8393 / HP / HC-P1:03.04.25

Hillingdon Council
Civic Centre, High Street
Uxbridge
UB8 1UW
Your Ref: 957/APP/2024/2765

Island Site, Eskdale Road, Hillingdon, UB8 2RT

We are writing in response to the updated Planning Application Review Form completed by Hillingdon Council dated 12th March 2025, reference 957/APP/2024/2765. We have reviewed the further comments within Section 5 and respond as below.

PROPOSED BELOW-GROUND DRAINAGE STRATEGY

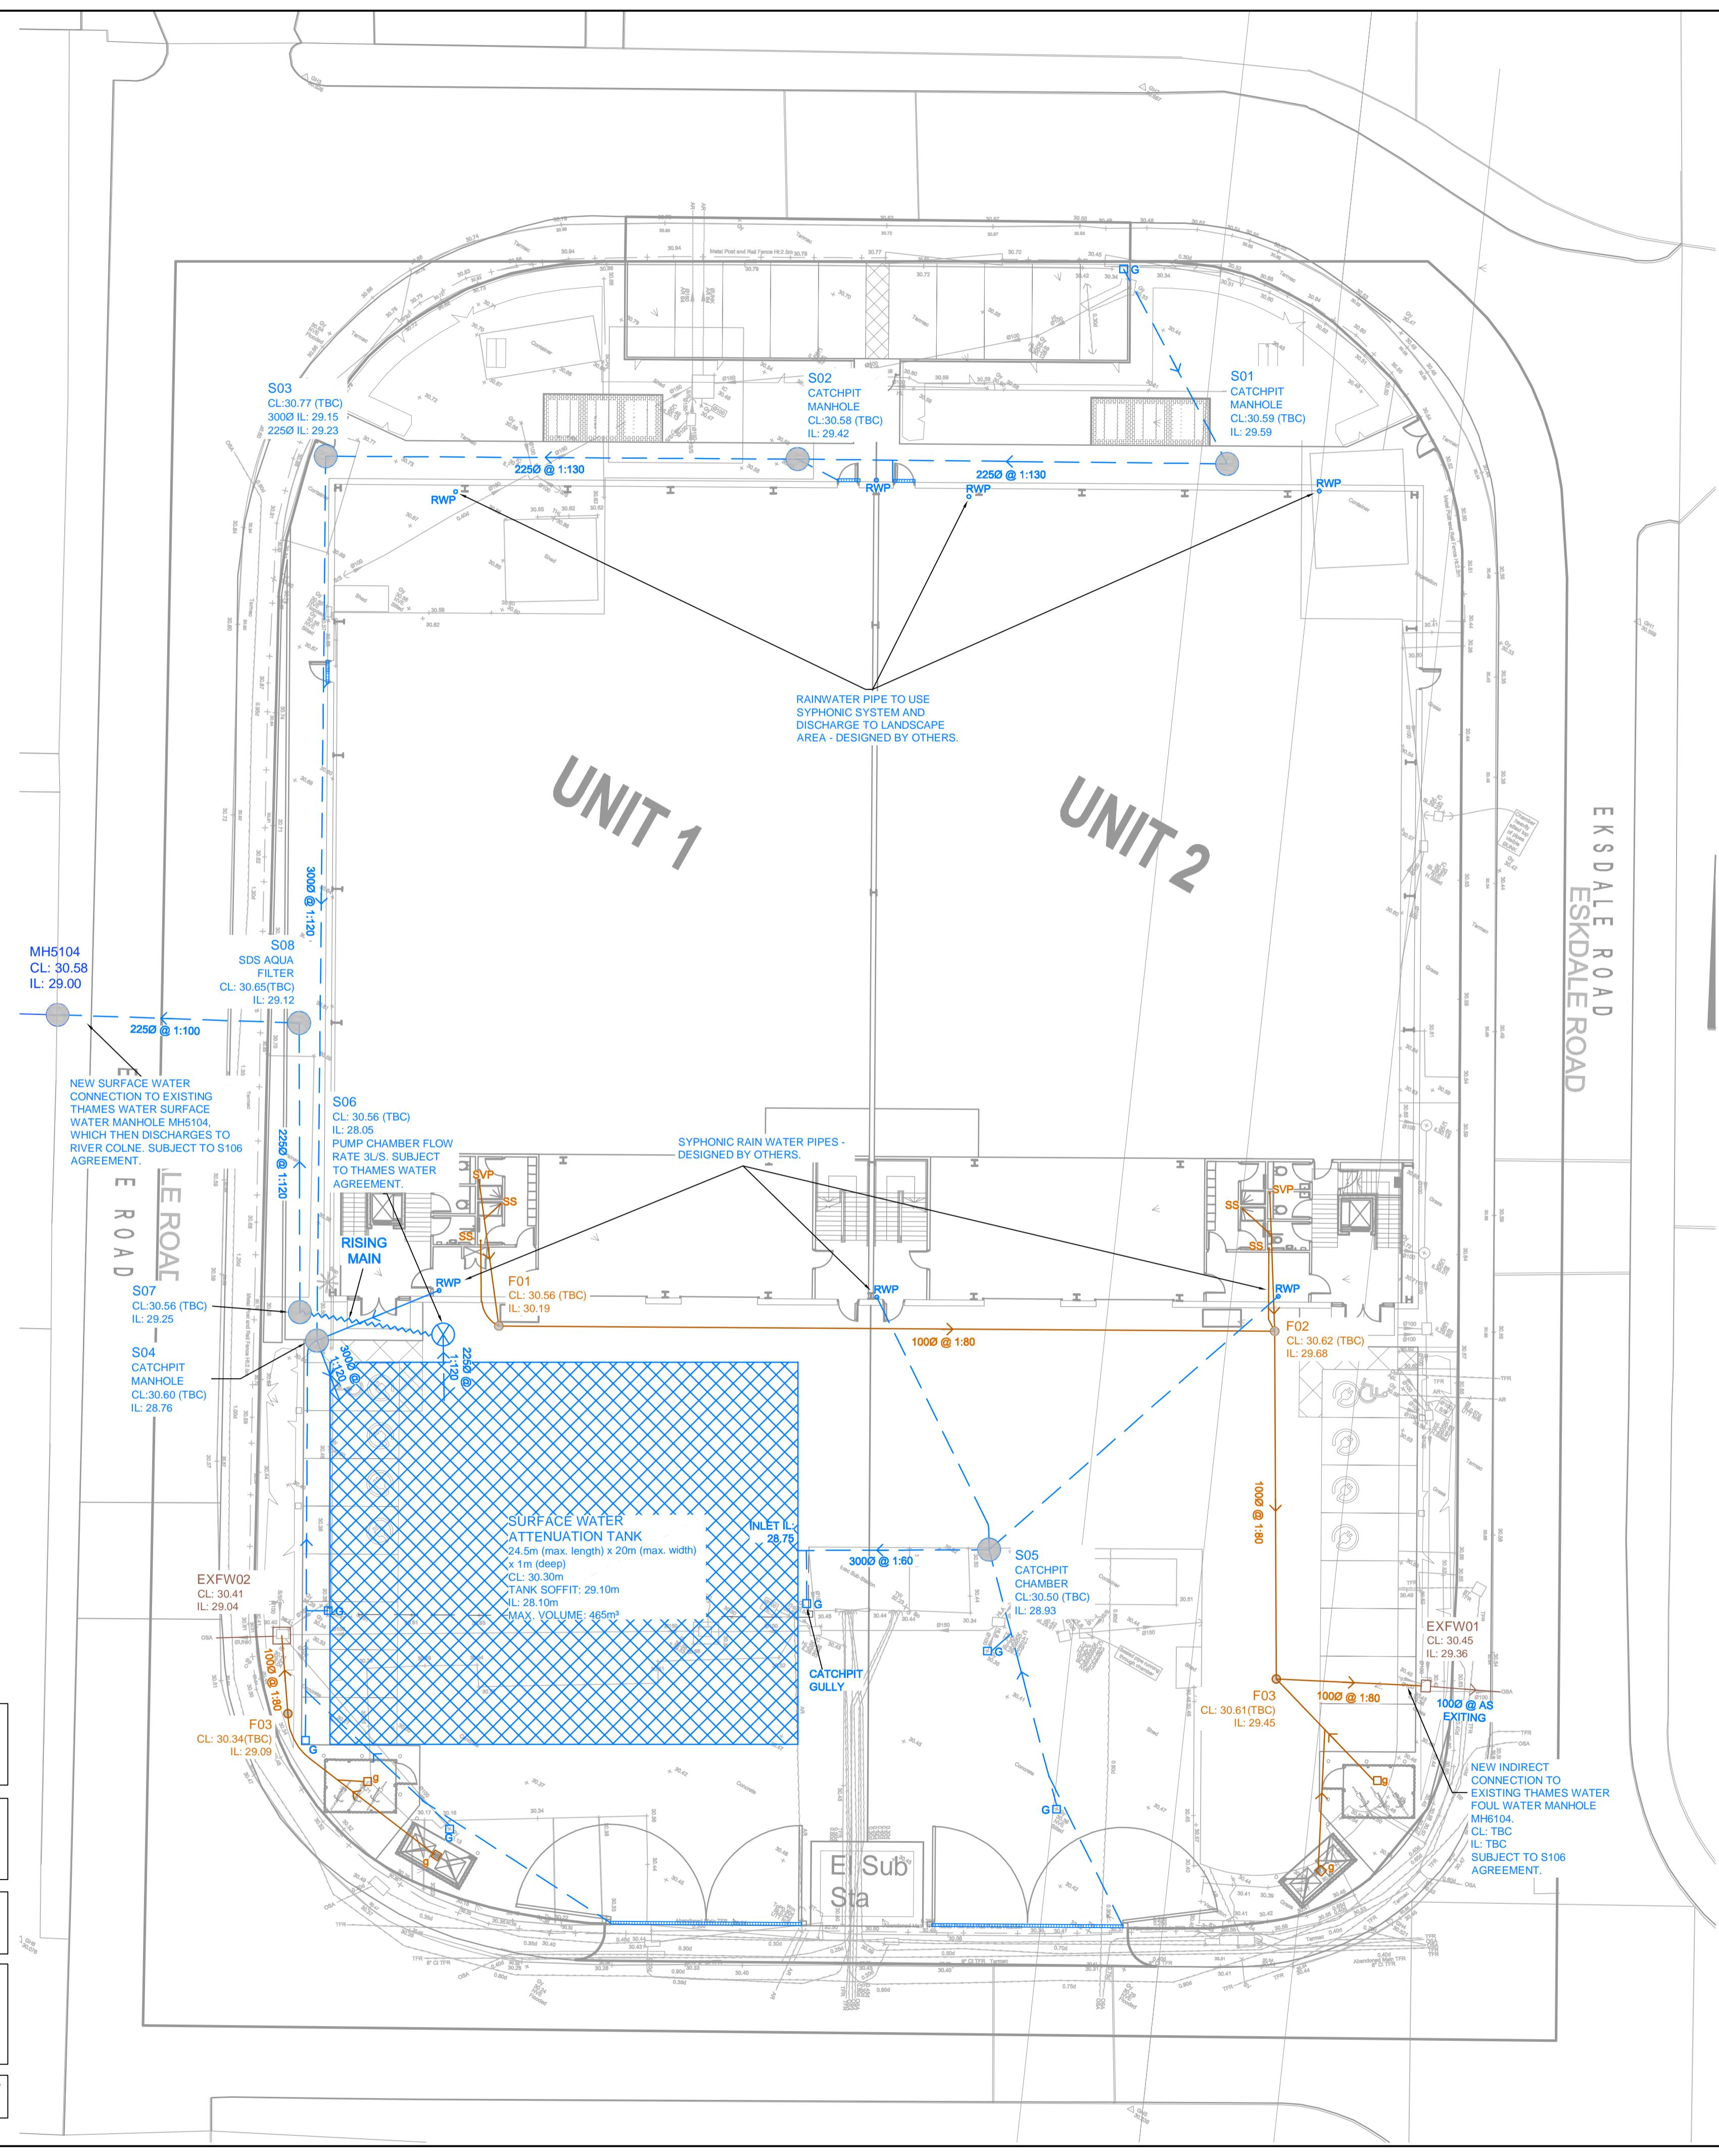
Drainage Calculations

These now include the total site area amounting to 0.53 hectares, and the latest FEH 2022 rainfall data has been used. The proposed drainage strategy plan has been updated to reflect the larger below ground attenuation tank required and is included in Appendix A, together with the drainage model calculations summary.

Rev	Date	Comment	By	Check
P02	04.04.25	SIZE & DEPTH OF ATTENUATION INCREASED	HP	HP
P01	04.10.24	STAGE 2 ISSUE	PS	HP

Appendix B – Exceedance Flow Routes Plan

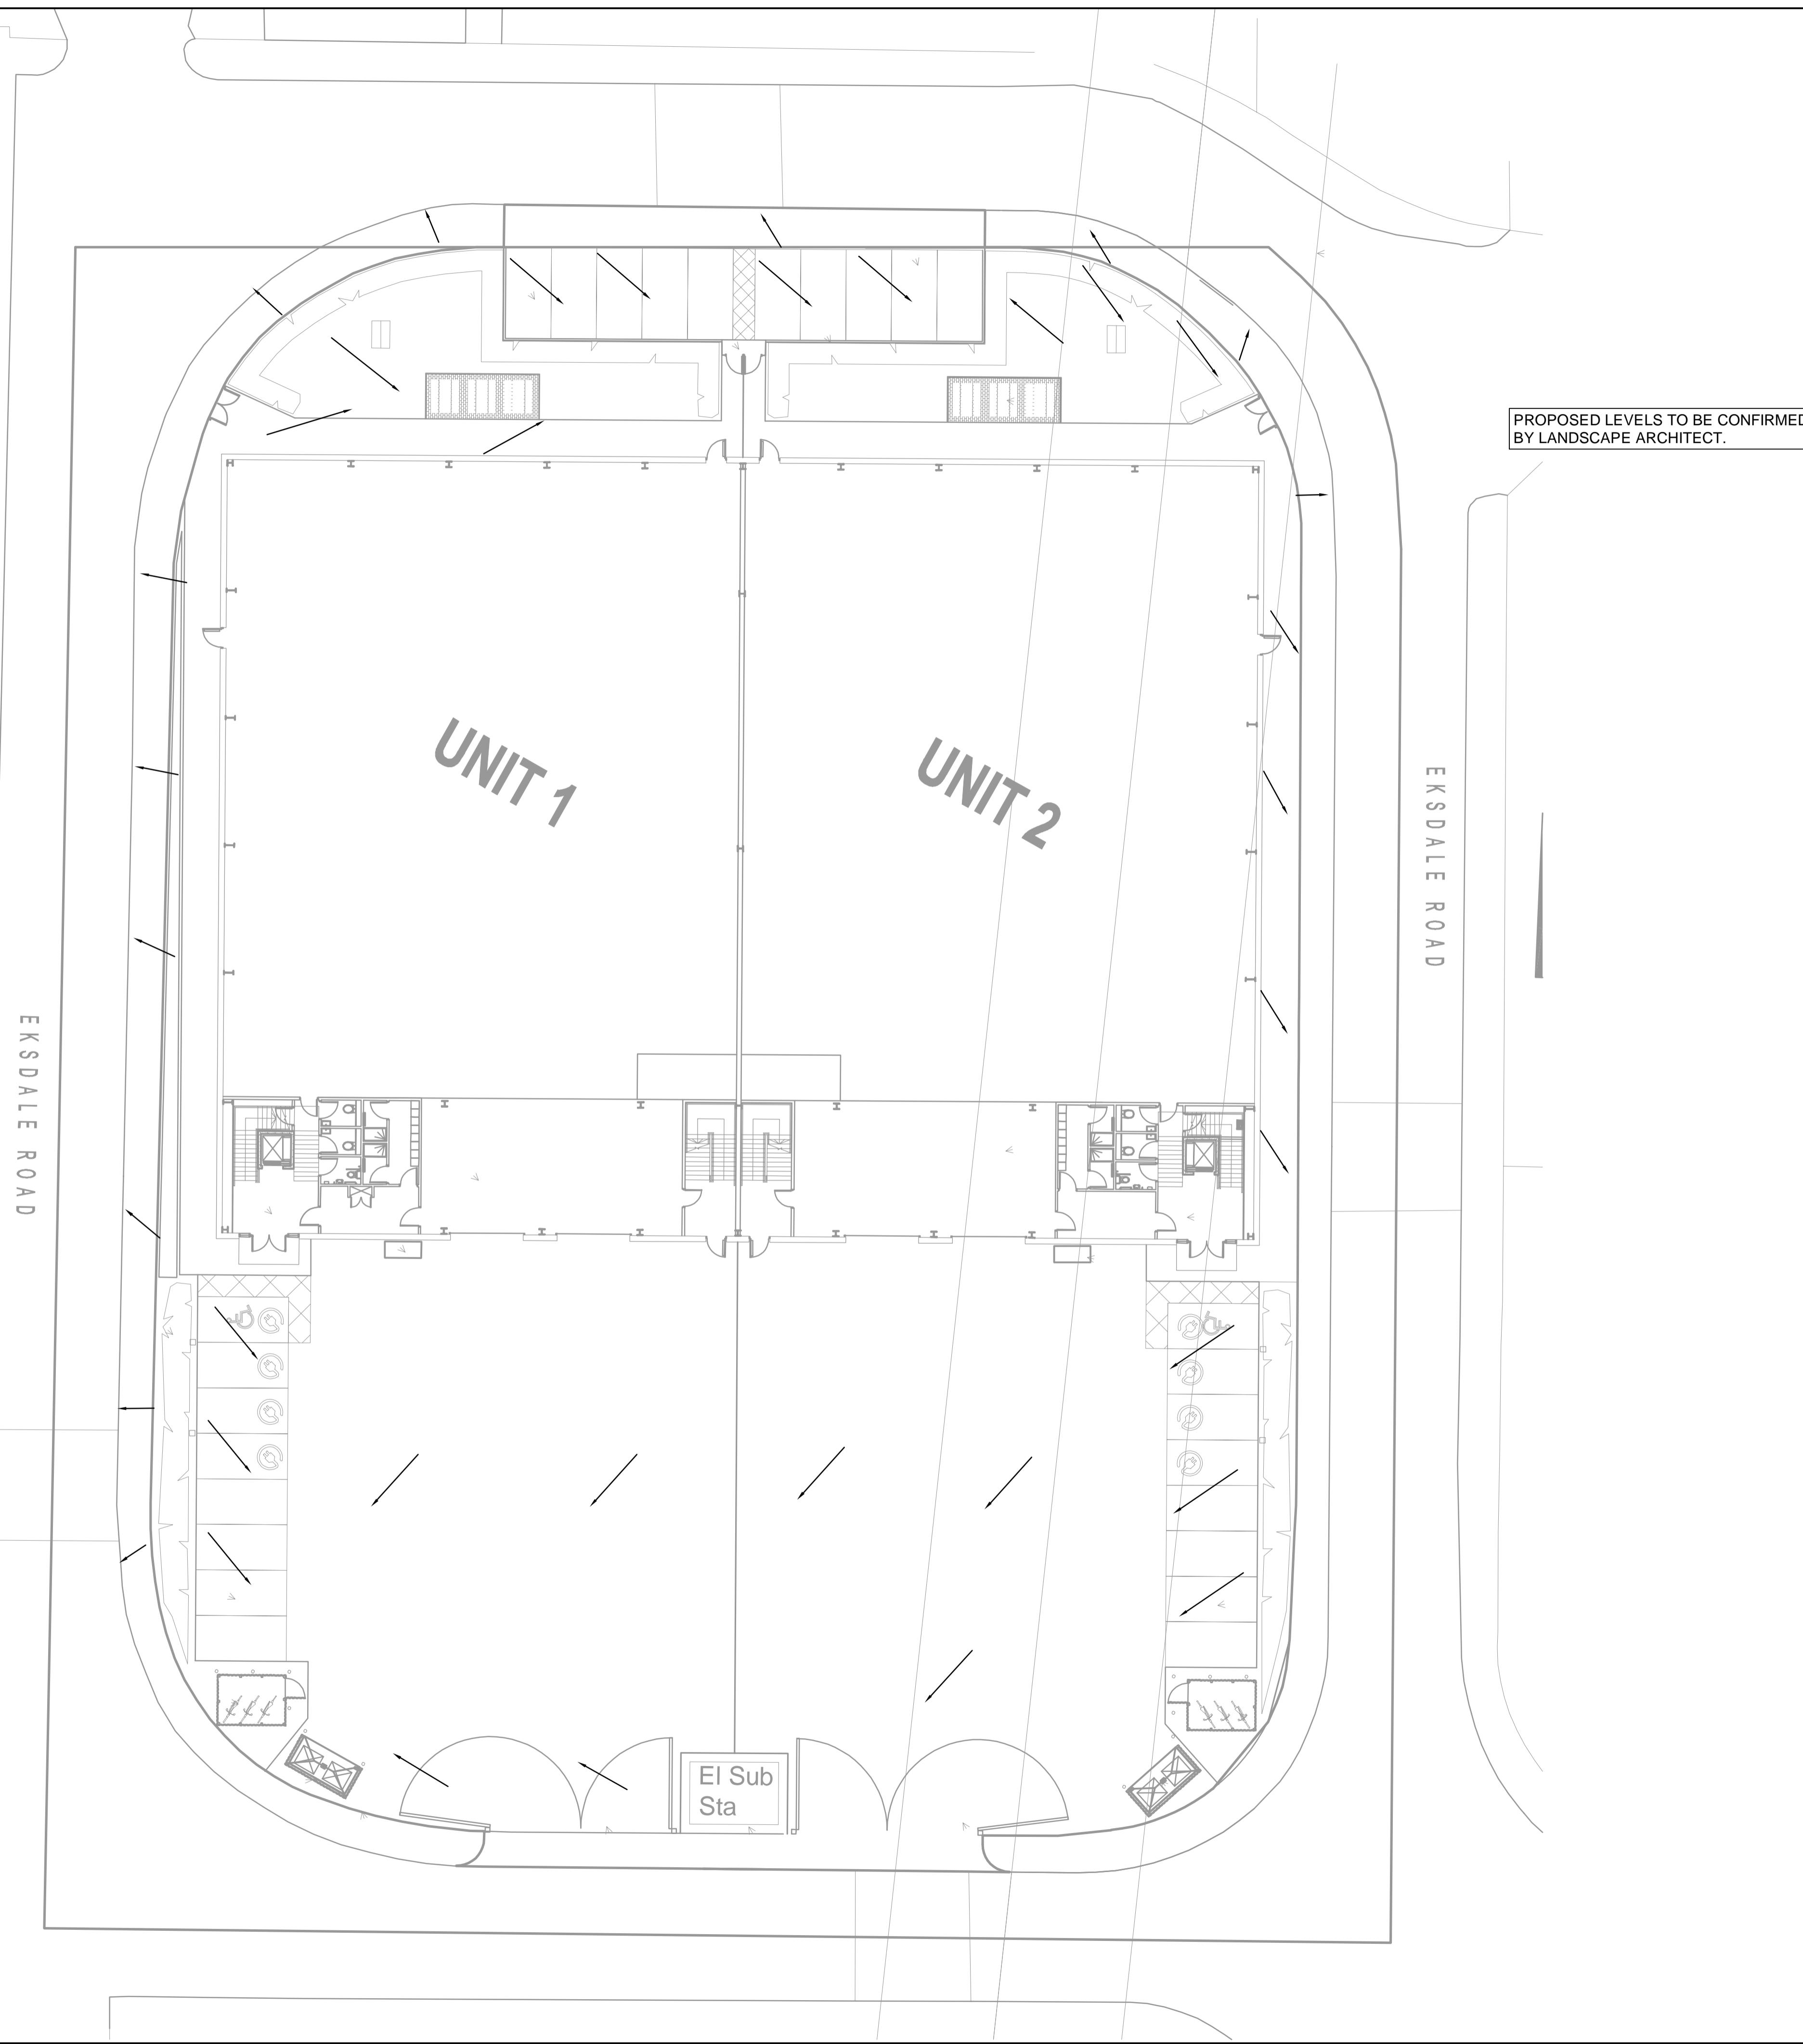
Exceedance Flow Route Plan

The external levels of the western side of the site are existing. The finished design levels have not yet been finalised, and so the exceedance plan has been based on the current levels. It is expected that during detailed design, these finished ground levels around the perimeter of the building will be fully considered and designed to fall away towards the Eskdale Road. We have included the updated exceedance flow routes plan showing the exceedance flow routes based on proposed ground levels, in Appendix B.
